RE: Updated Revised Addendum to the May 2009 Supplemental RI Work Plan  
Sherwin-Williams/Hilliard's Creek Site – Former Manufacturing Plant,  
Gibbsboro, New Jersey  
*Administrative Order Index No. II CERCLA-02-99-2035*  
Incorporation of West Clementon Road Residential Properties

Re: Addendum to the May 2009 Supplemental RI Work Plan  
Sherwin-Williams/Hilliard's Creek Site – Former Manufacturing Plant,  
Gibbsboro, New Jersey  
*Administrative Order Index No. II CERCLA-02-99-2035*  
Incorporation of West Clementon Road Residential Properties, dated April 29, 2010

Proposed Grid Sampling Scheme  
West Clementon Road  
Residential Soil Sampling Program  
Modified 20-Foot Grid

<b>TITLE:</b>  Soil Sampling Protocol West Clementon Road Residential Properties	
<b>DATE:</b> Oct. 15, 2010	<b>FIGURE #:</b> 2

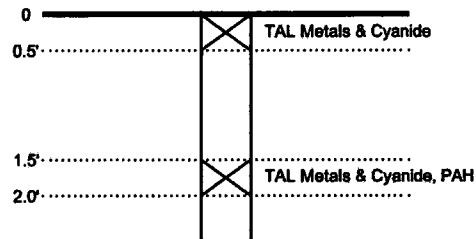
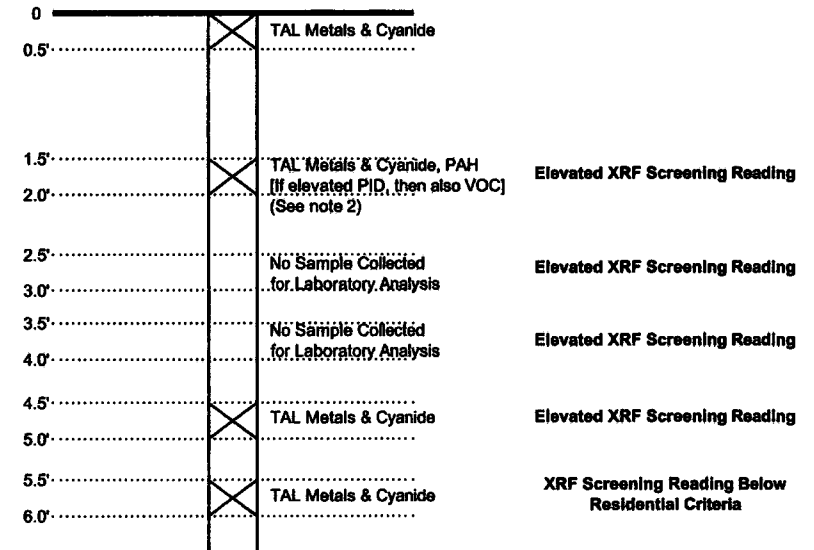
- When the XRF screening indicates that both arsenic and lead are less than the RDCSRS, then a sample will be collected from that 1-foot interval and submitted to the laboratory for TAL Metals plus cyanide analysis. A sample will also be collected from the 1-foot interval immediately above the bottom interval and submitted for the same TAL metals plus cyanide analysis. A Soil Sampling Protocol (Figure 2) is provided for reference.
